# **ITS3 activities in Bari**

## **BBM6**

# BBM6\_ThermalTestAssembly\_03-04-2024.stp

# 1) BEAM PIPE POSITION

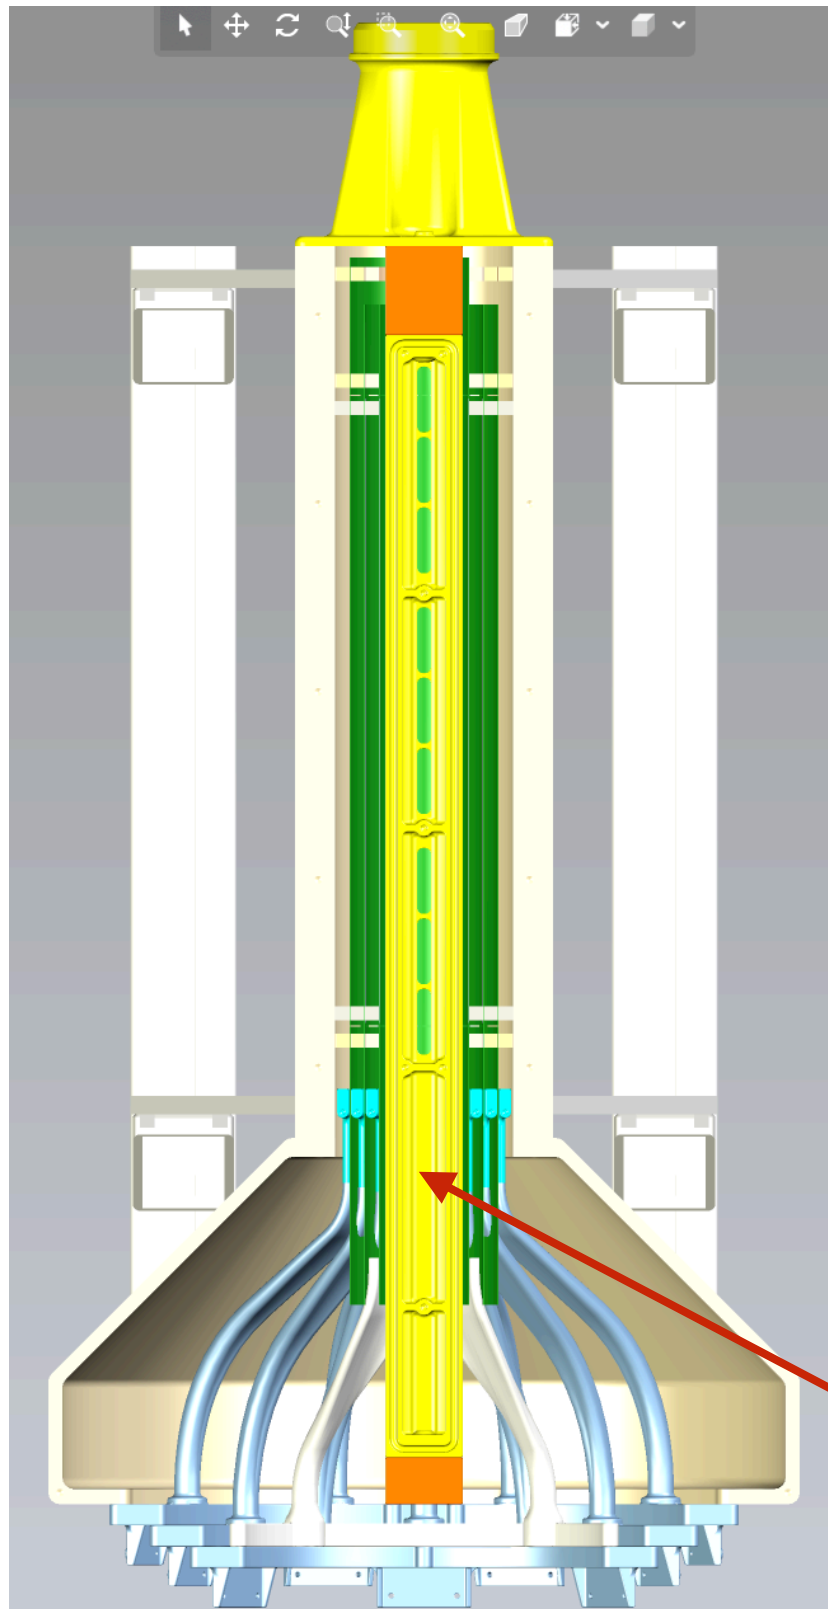
Is the positioning of the beam pipe (and particularly of the windows) fine with you?  
Present position is entering windows in the sensor area.

Alternative solution, if you need to have windows also in the FPC are, is to shift everything on the C-side and open windows in the last beam-pipe section.

Fixing of the extensions to the beam-pipe not yet defined in the CAD.

Potentially, open new windows here

## 2) AIR DUCTS

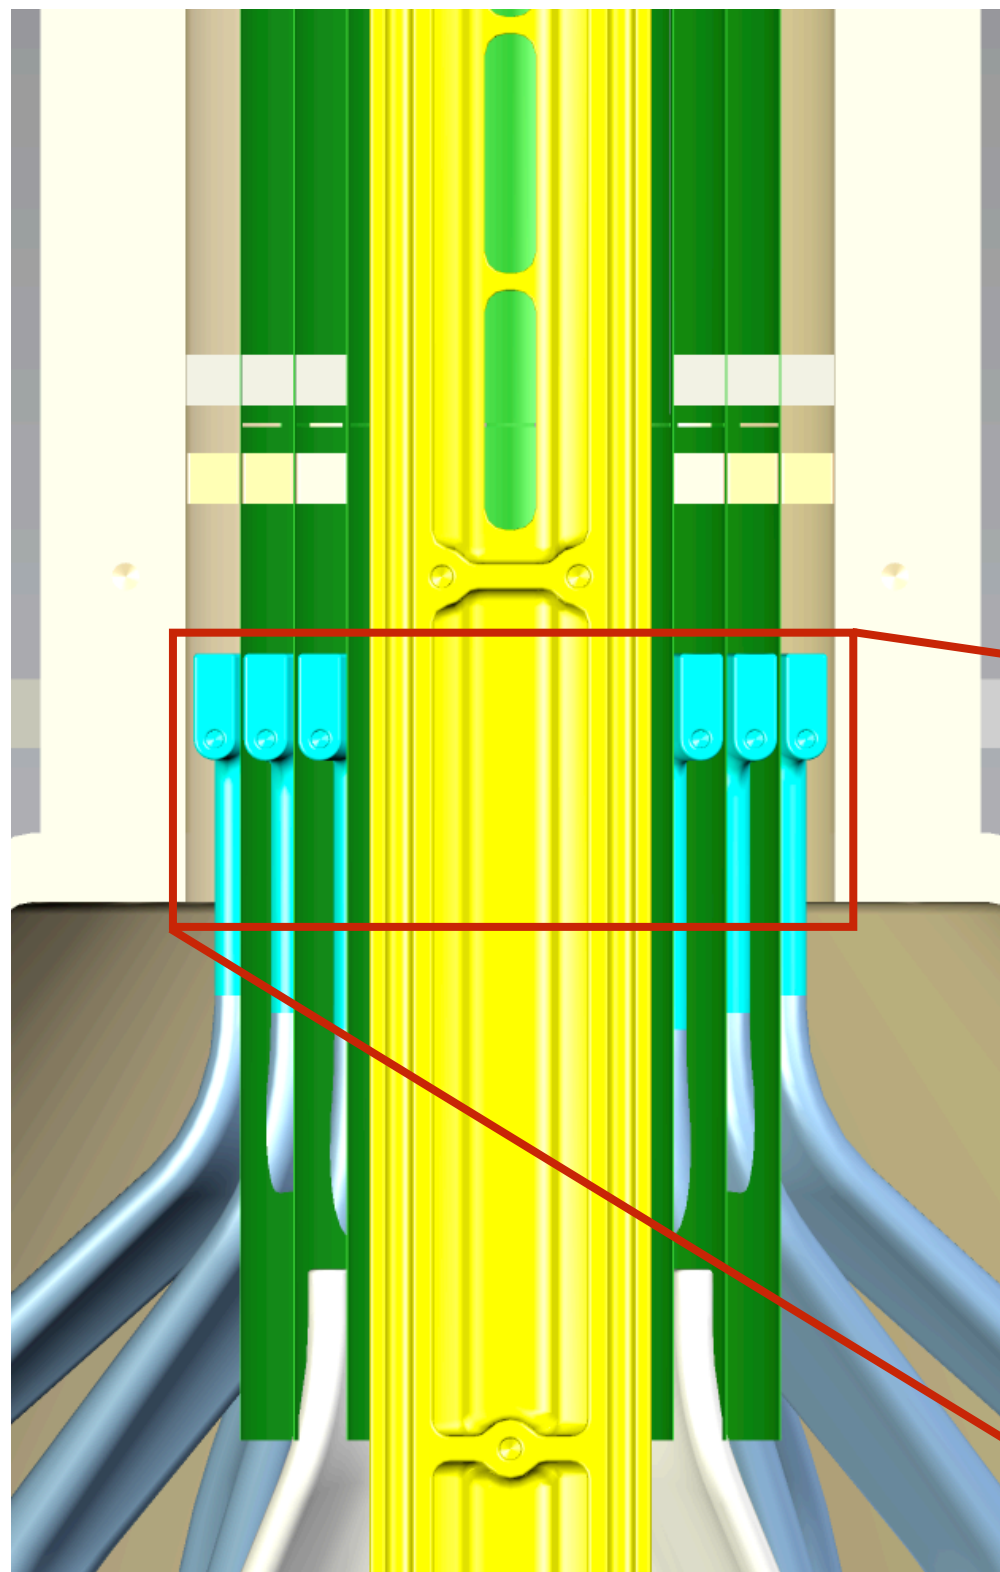
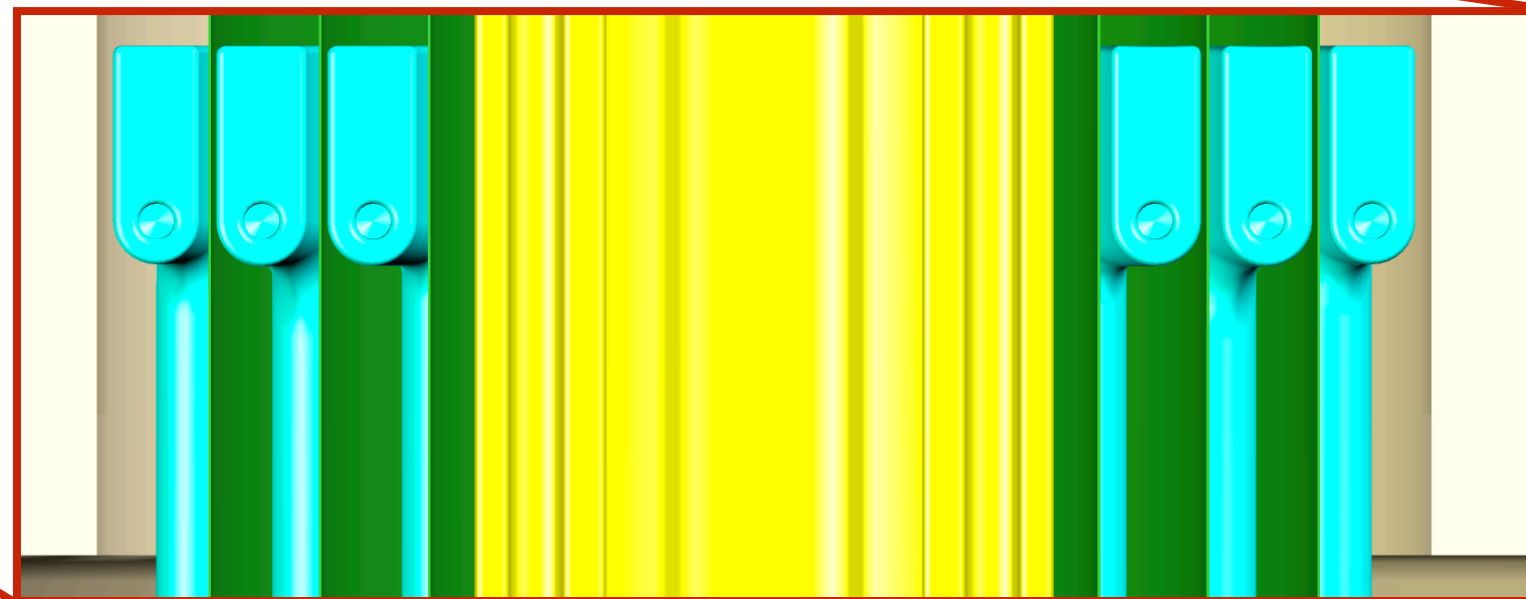
Thickness of the air ducts to be fixed.

## 2) AIR DUCTS

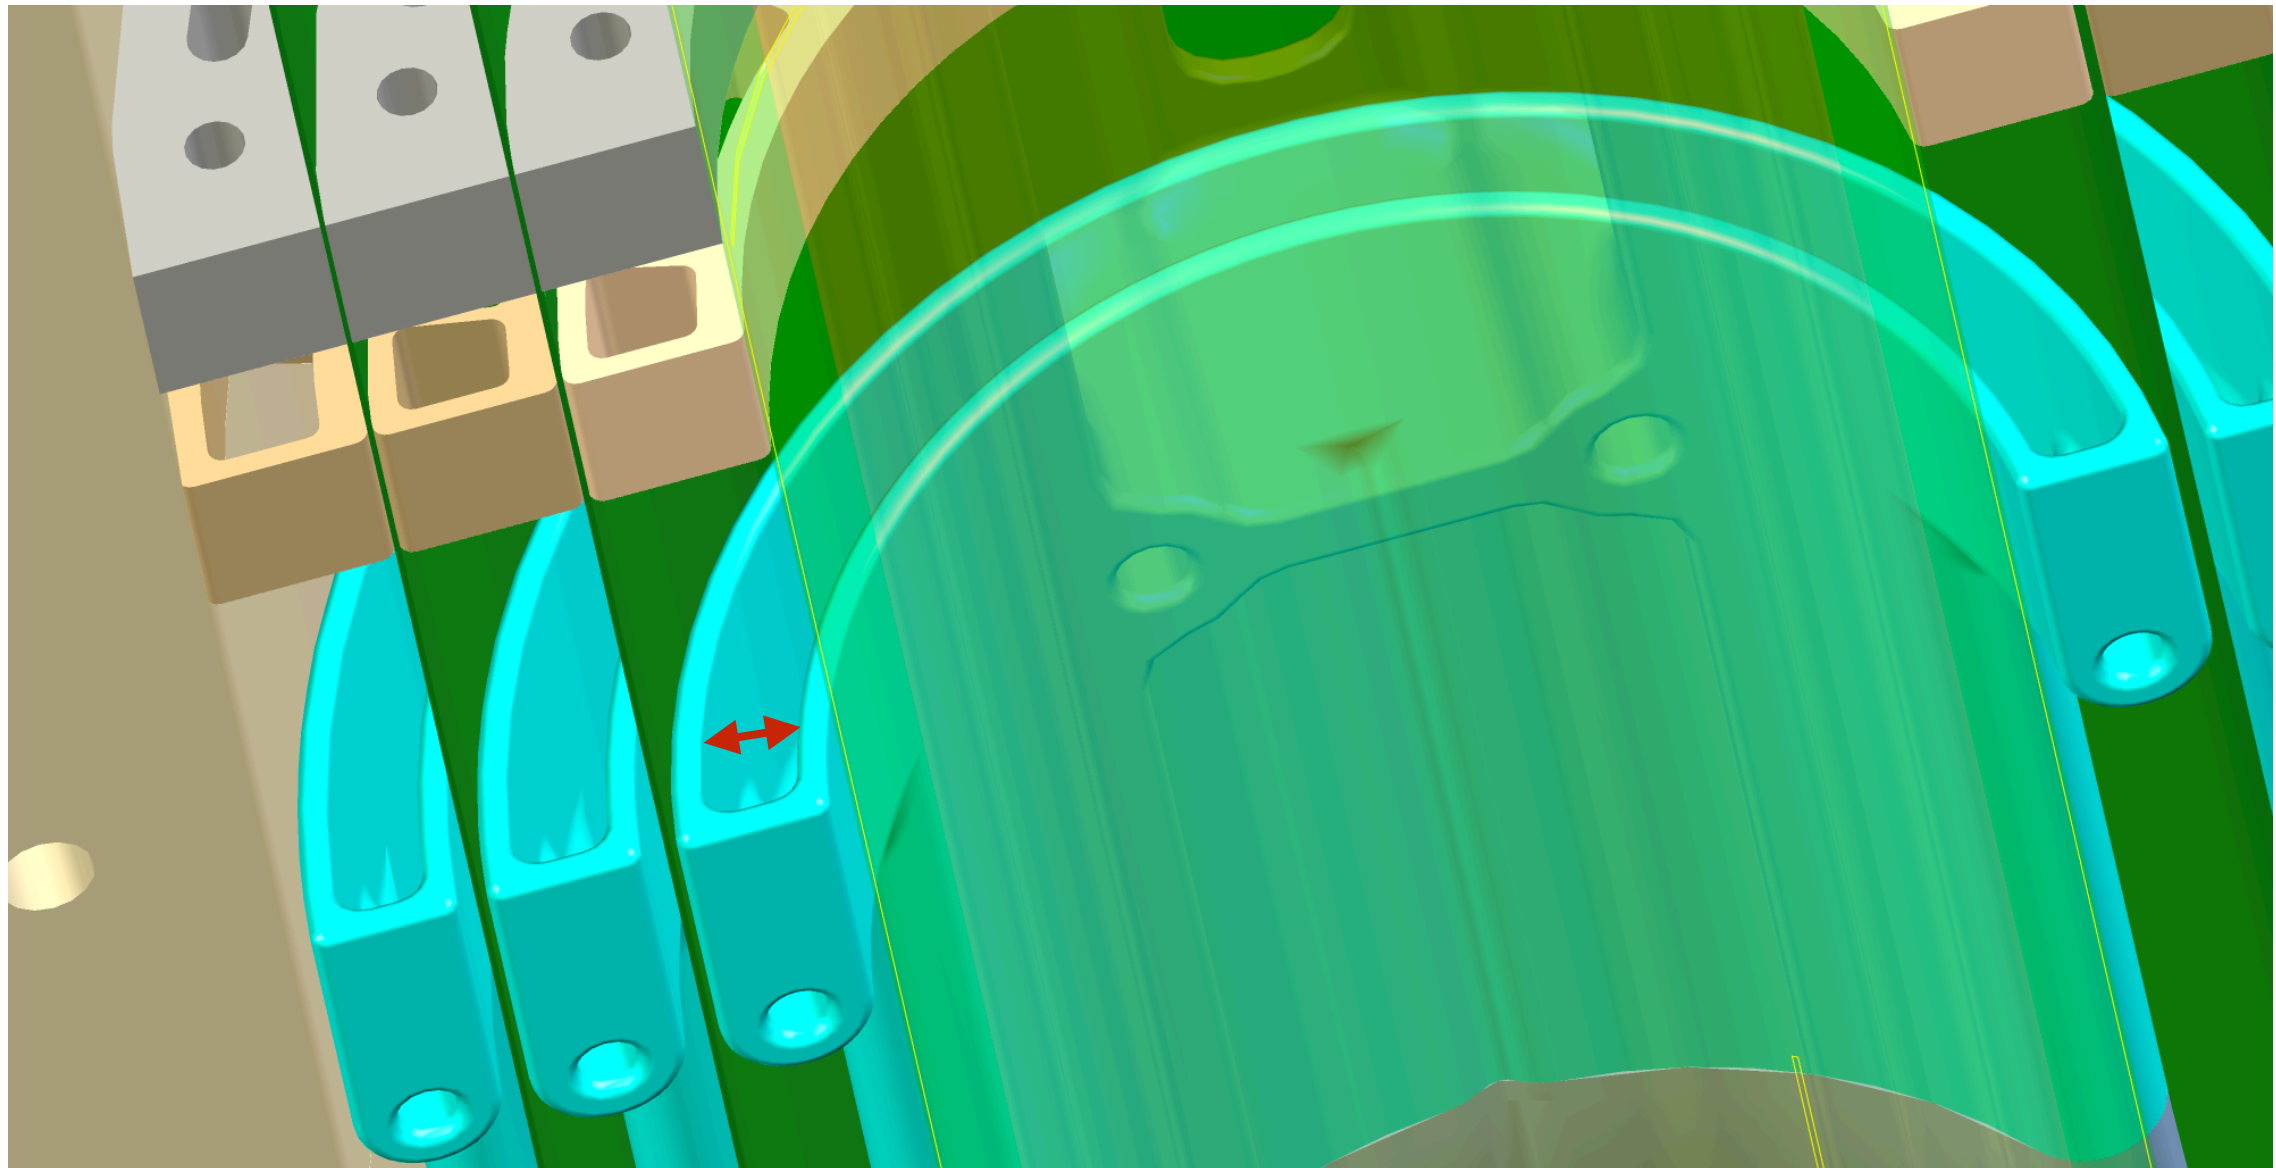
If no update from Gael, proposed solution is to keep fixed internal dimension and make thicker wall from external side, filling the missing volume.

### 3) AIR DUCTS CONNECTION TO THE SHELLS

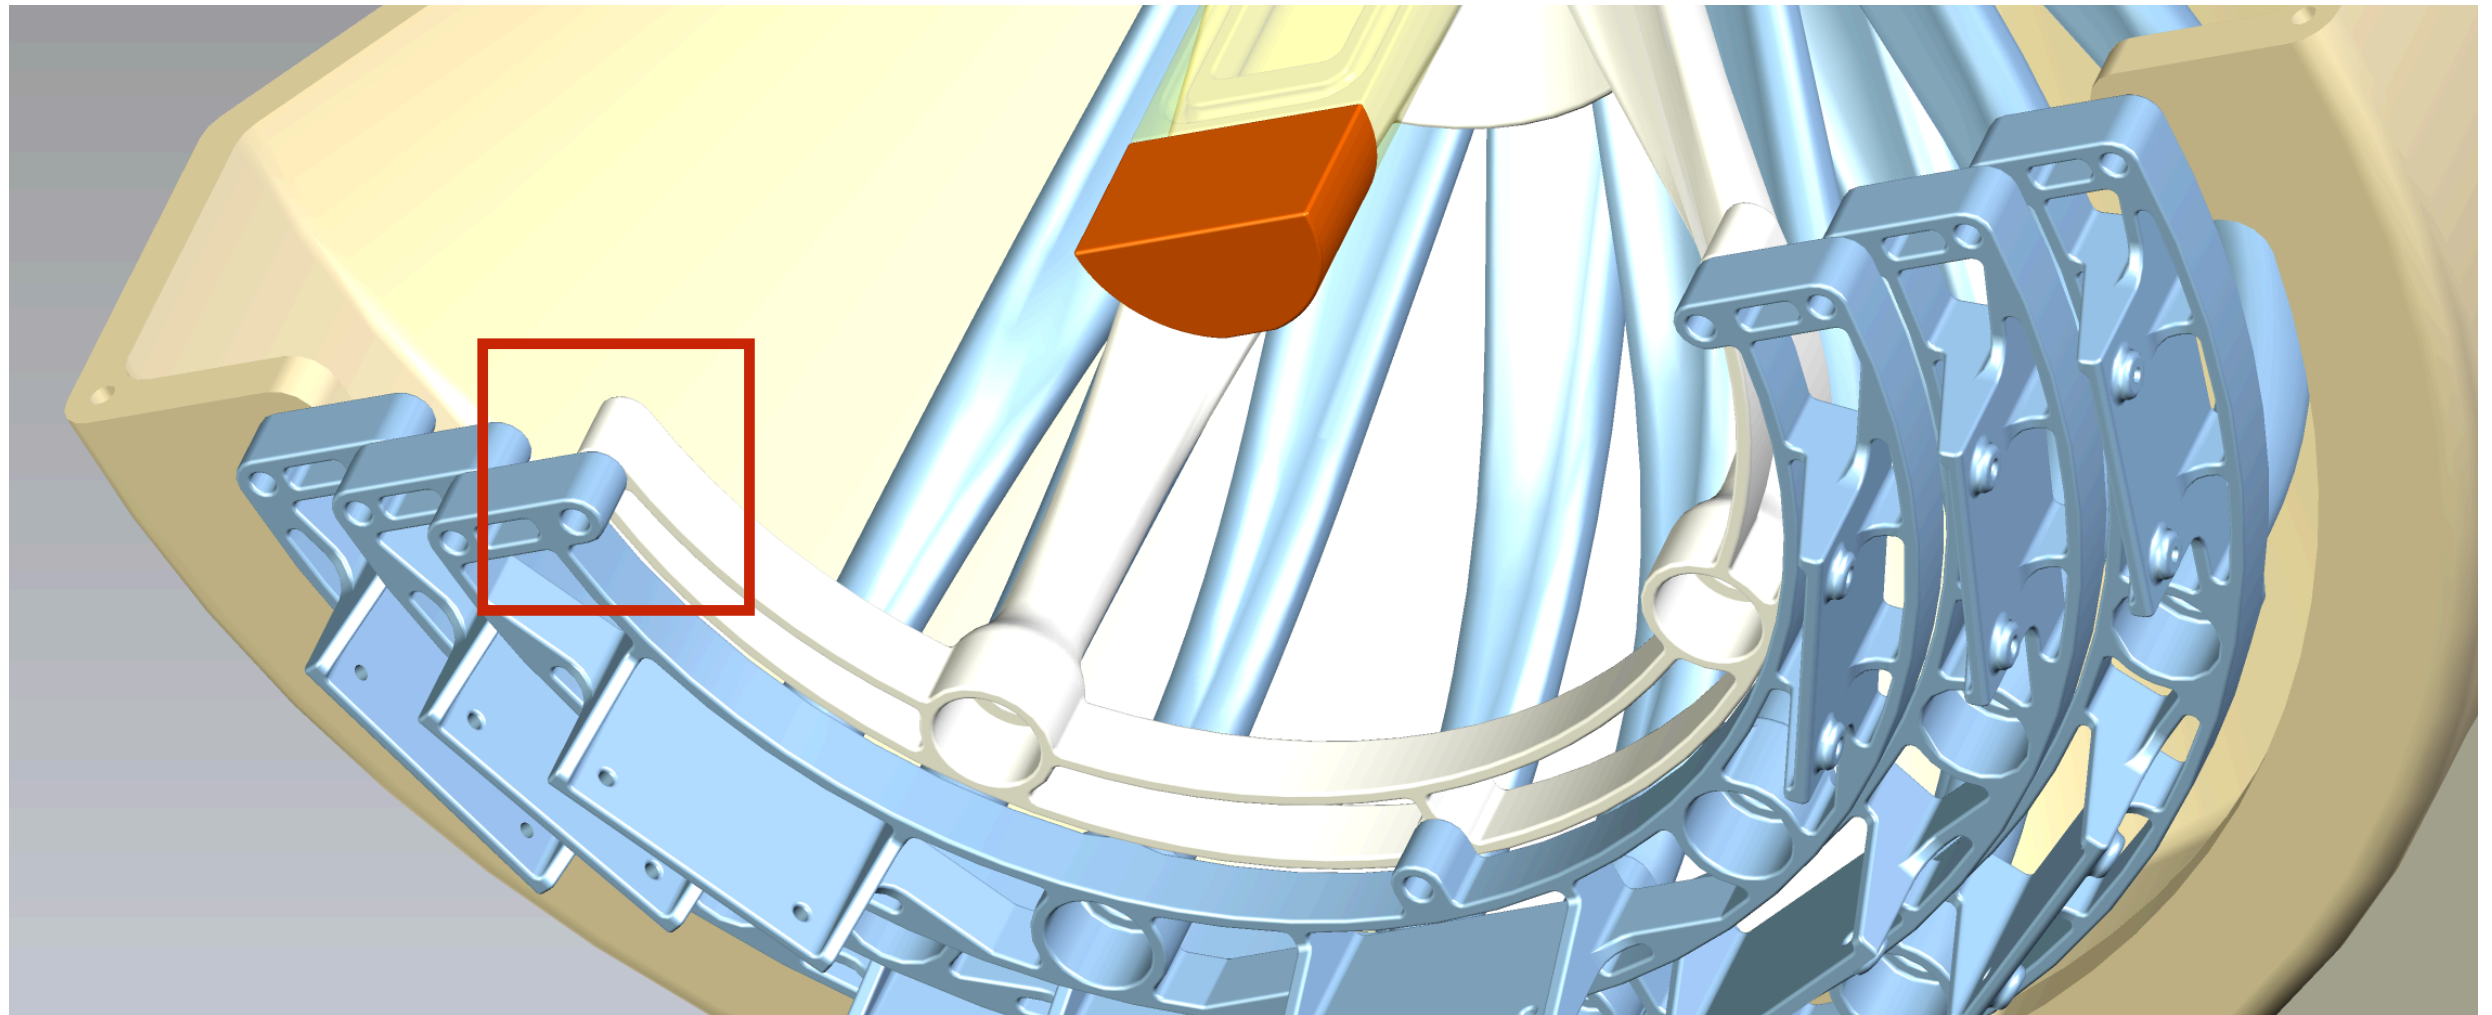
Can you give us details about the connection between the end of air ducts and the patch panel?

Do we actually need to have the patch panel?
